April 26, 2024

RE: Thorndike Place, Arlington, MA

February 16, 2021

RE: Arlington Land Trust – Weston & Sampson Resiliency Review

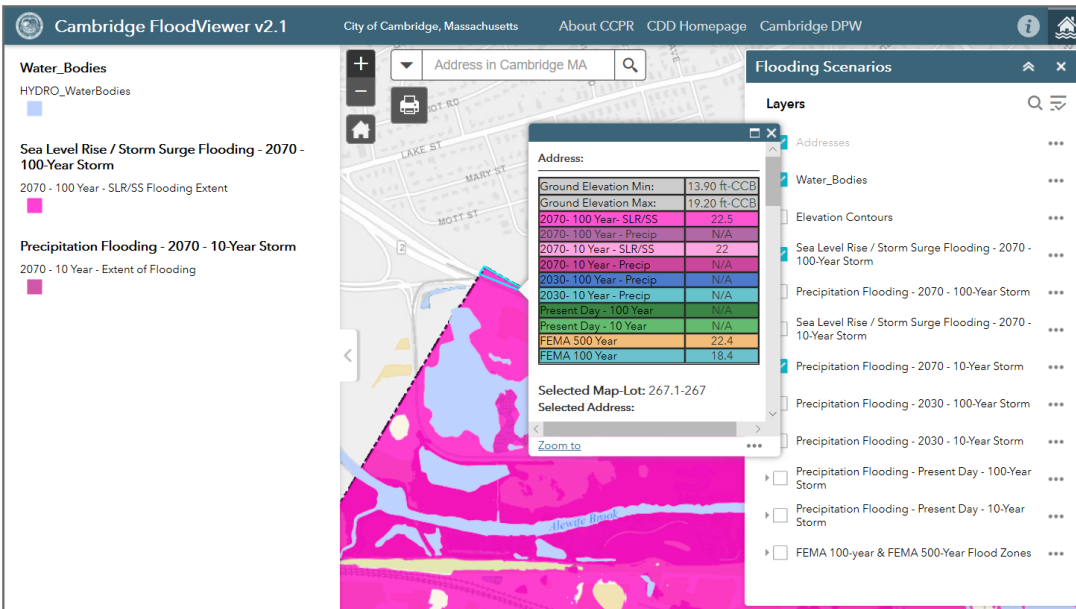
- Figures 1 through 7 of the Weston & Sampson memorandum depict scenes after previous storm events. It is important to note that the figures primarily depict locations east of the Minuteman Bikeway, adjacent to Alewife Brook, located within the FEMA Floodway and at elevations approximately 3 – 5 feet lower than the area of the Site proposed for development. These Figures are not representative of the area of the Site proposed for development.
